Well Name: BREECH F	Well Location: T27N / R6W / SEC 35 / NENW / 36.535934 / -107.439178	County or Parish/State: RIO ARRIBA / NM
Well Number: 10	Type of Well: CONVENTIONAL GAS WELL	Allottee or Tribe Name:
Lease Number: NMNM03547	Unit or CA Name:	Unit or CA Number:
US Well Number: 300392093600S1	Well Status: Gas Well Shut In	Operator: CROSS TIMBERS ENERGY LLC

Notice of Intent

Type of Submission: Notice of Intent	Type of Action: Plug and Abandonment
Date Sundry Submitted: 10/11/2023	Time Sundry Submitted: 02:52
Date proposed operation will begin: 10/31/2023

Procedure Description: Cross Timbers Energy, LLC requests approval to P&A the Breech F #10. Attached is the Proposed Procedure and Current and Proposed WBDs.

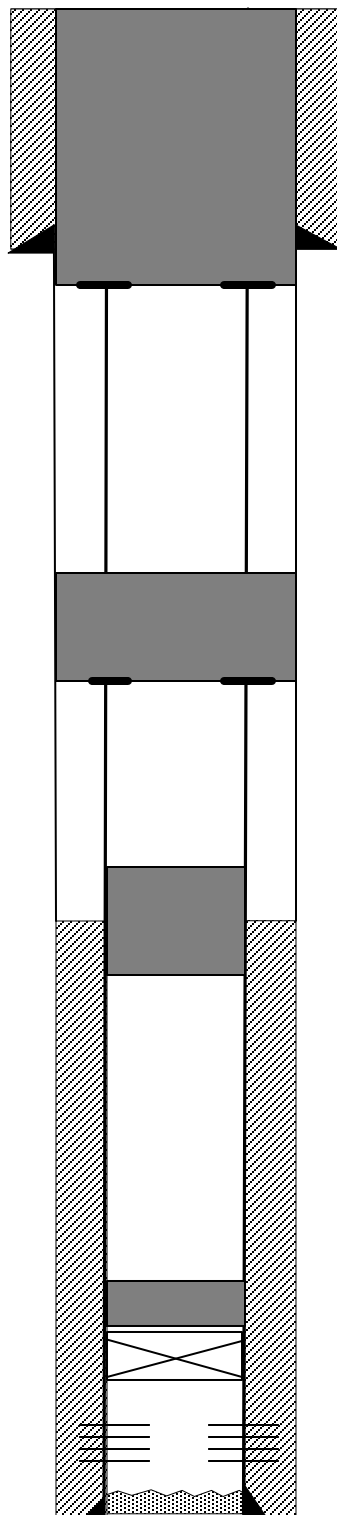
- a. Adjust Nacimiento plug (plug 3) to cover 50' above BLM formation top pick at 1210'.

1. Plugging operations must be completed by April 30, 2024.
2. Plugging operations authorized are subject to the attached "General Requirements for Permanent Abandonment of Wells on Federal and Indian Lease."
3. The following modifications to your plugging program are to be made:
 - a. Adjust Nacimiento plug (plug 3) to cover 50' above BLM formation top pick at 1210'.
4. Farmington Office is to be notified at least 24 hours before the plugging operations commence at (505) 564-7750.

Plug 3 (~Nacimiento) – perf @
1260' attempt to establish
circulation, Pump/circ. Cmt to
1110' w/55 sx if no circ., ~7 sx
need to cap inside casing

Proposed P&A

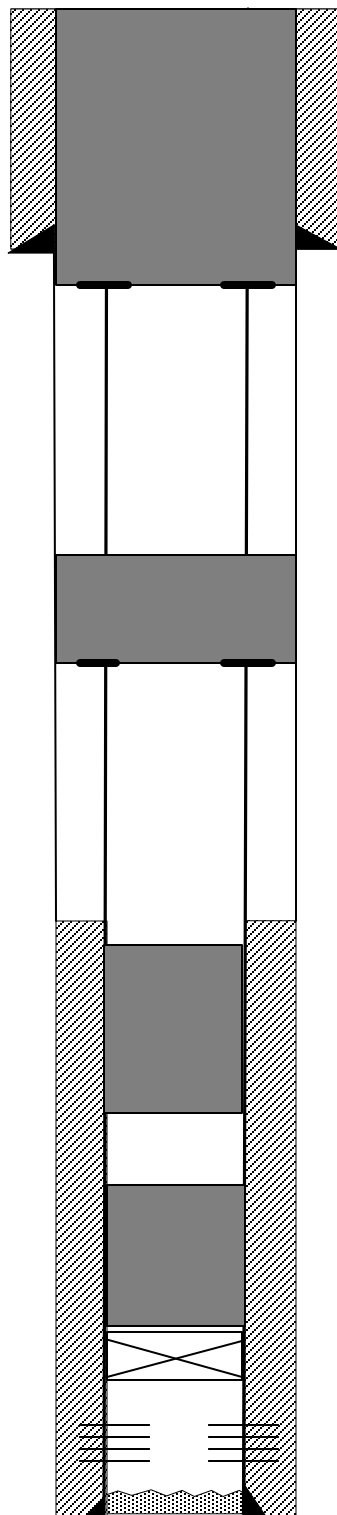
Created By	Condition	Condition Date
mkuehling	once perforation is performed at 180 feet wait 30 minutes to check for gas at surface before proceeding. Notify NMOCD 24 hours prior to moving on	10/26/2023

Plug 4 (Surf Shoe) – perf
@ 180' attempt to
establish circulation,
Pump/circ. Cmt to surf
w/~70 sx if no circ., ~8 sx
need to cap inside casing

Plug 3 (~Nacimiento) – perf @
1260' attempt to establish
circulation, Pump/circ. Cmt to
1110' w/55 sx if no circ., ~7 sx
need to cap inside casing
